DEPARTMENT OF PLANNING AND ZONING PLANNER'S REPORT

DATE: September 9, 2019
TO: Tonya Hutson
FROM: Michael Smith
RE: **Design Review – 219 Maple Street Remodel**

The City of Hapeville has received a design review application from Daniel Moore to remodel a front porch and a rear deck on an existing single-story single-family dwelling at 219 Maple Street. The porch roof addition will increase the heated floor area by 160 sq. ft. from 1,400 sq. ft. to 1,560 sq. ft.

ROOF FRAMING PLAN

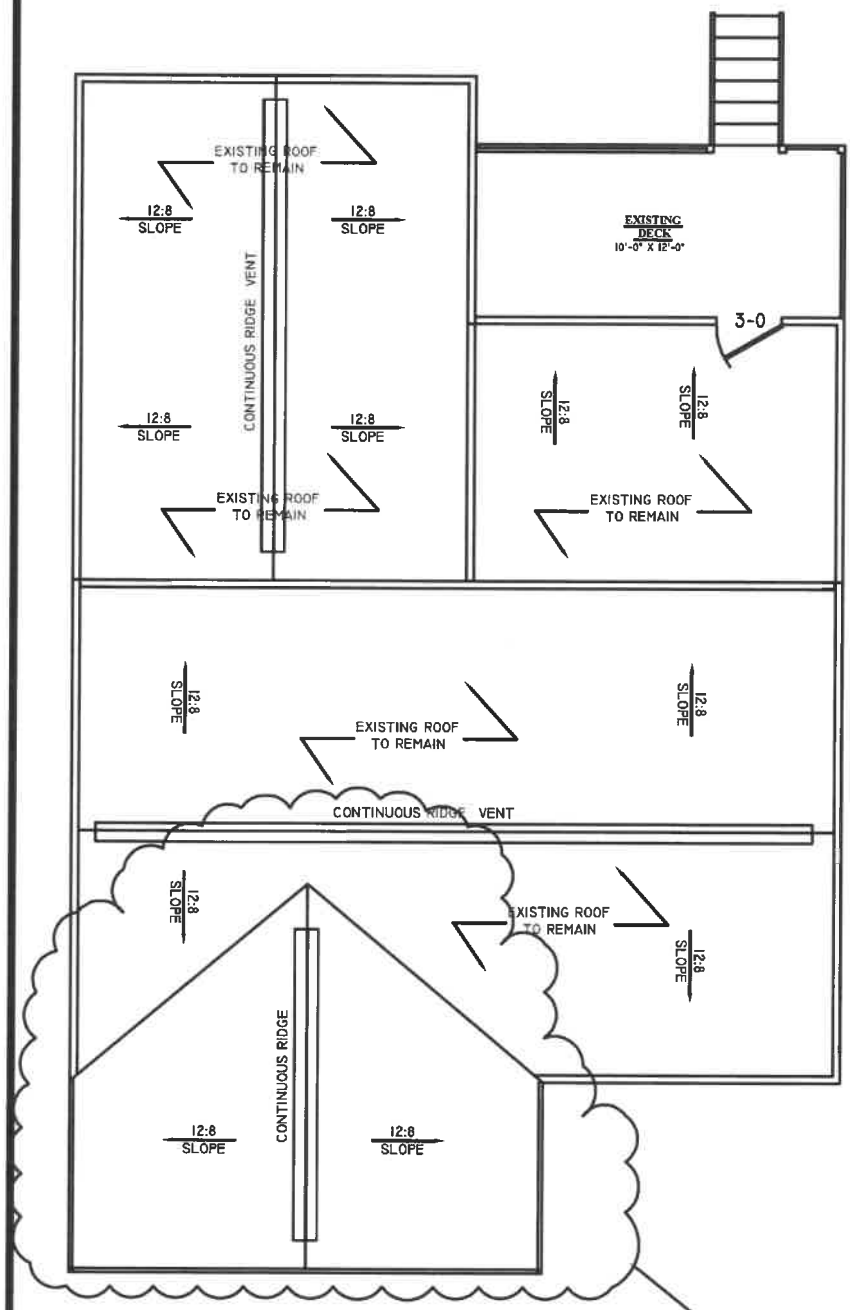
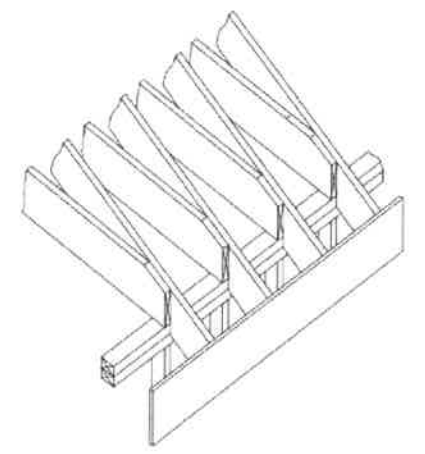
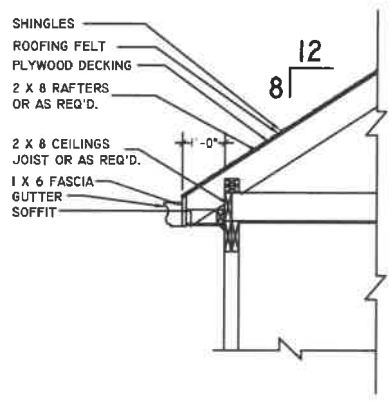
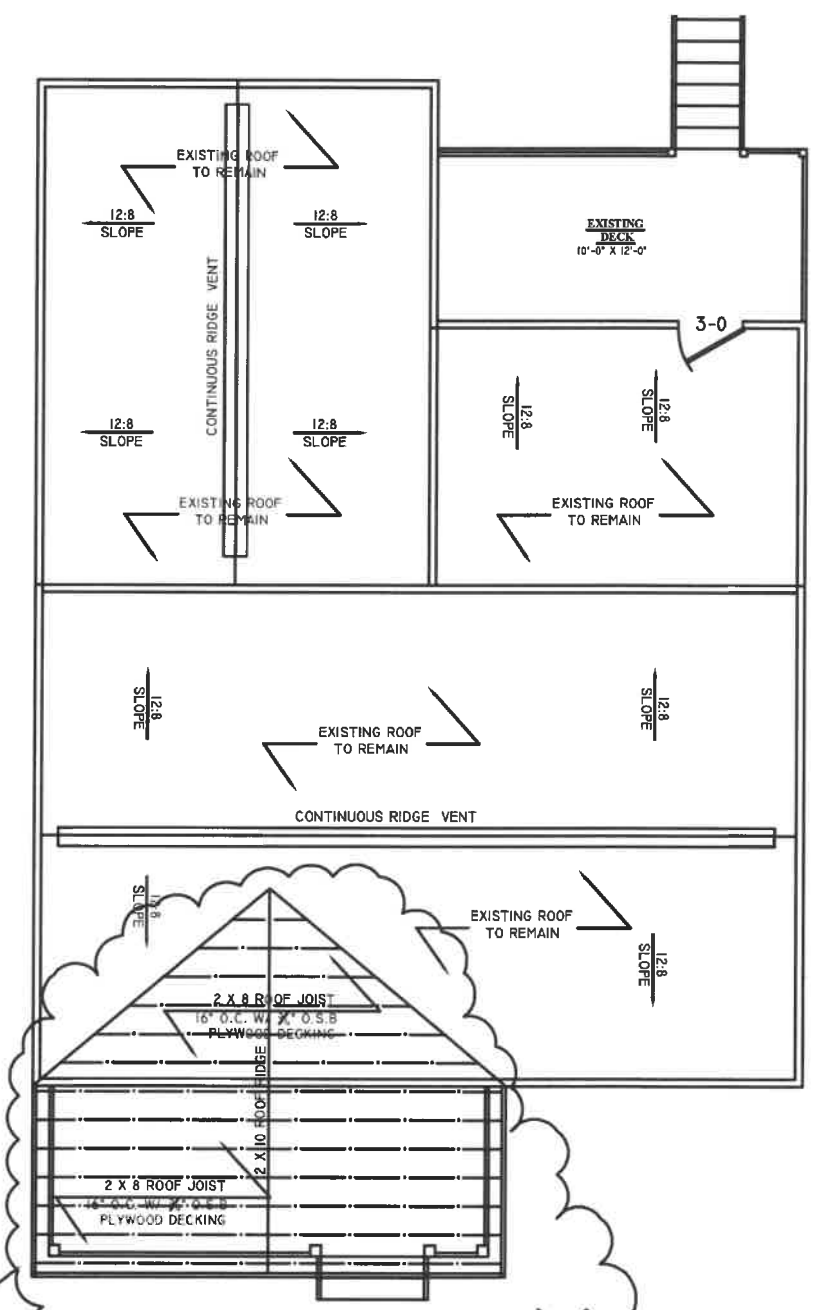
- The applicant should ensure the shingles for the proposed porch roof match the existing shingles in style and are guaranteed for at least 30 years by manufacturer's warranty.
- The applicant should show gutters and downspouts on the new roof and provide their material.
- The applicant should ensure the new roof overhangs at least 12" beyond the facade.

3. The applicant should show gutters and downspouts on the new roof and provide their material.
4. The applicant should ensure the new roof overhangs at least 12" beyond the facade.
